Access Compliance Report

Public Rights-of-Way

(Curb Ramps)

Intersection ID: 12370	Main Street: CLARKSON_ST	Cross Street: POST_ST	Location:	E
ADA ID: C197EEC96145	Ramp Type: BlendTrans1	Initial Pass/Fail: Fail	Overall Compliance: No	Severity Score: 12.5
Codes/Mitigation Info/Possible Solution		Field Measurements/Component Compliance

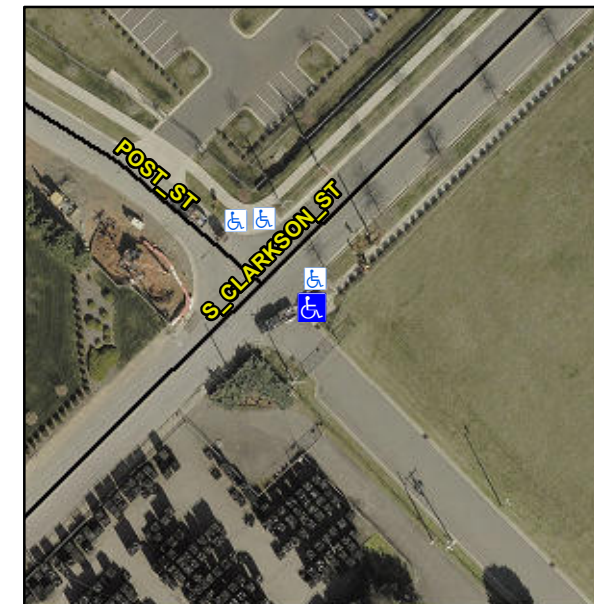
Compliance	Description	Data	Compliance	Description	Data
N/A	Ramp Length (in)	28.0	Yes	BlendTrans Slope (%)	3.5
Yes	Ramp Width (in)	48.0	No	BlendTrans XSlope (%)	6.3
N/A	Flare Type LT	N/A	N/A	Flare Type RT	N/A
N/A	Flare Slope LT (%)	N/A	N/A	Flare Slope RT (%)	N/A
N/A	Flare Traversable LT?	N/A	N/A	Flare Traversable RT?	N/A
N/A	Landing Length (in)	N/A	N/A	DWS Provided?	N/A
N/A	Landing Width (in)	N/A	N/A	DWS Contrast?	N/A
N/A	Landing Slope (%)	N/A	N/A	DWS Length (in)	N/A
N/A	Landing X Slope (%)	N/A	N/A	DWS Full Width?	N/A
N/A	Landing Curb? (Y/N)	N/A	N/A	DWS Offset (in)	N/A
N/A	Shared Landing?	N/A			
N/A	Gutter Ponding?	N/A	N/A	Gutter Slope (%)	N/A
N/A	Gutter Lip Ht (in)	N/A	N/A	Gutter X Slope (%)	N/A
N/A	Painted X Walk1?	No	N/A	Painted X Walk2?	N/A
	X Walk 1 Direction	To SW		X Walk 2 Direction	N/A
	X Walk 1 Width (in)	N/A		X Walk 2 Width (in)	N/A
	X Walk 1 Slope (%)	1.6		X Walk 2 Slope (%)	N/A
	X Walk 1 X Slope (%)	5.2		X Walk 2 X Slope (%)	N/A

Remove & Replace Curb Ramp With Two New Directional Ramps or Equivalent.
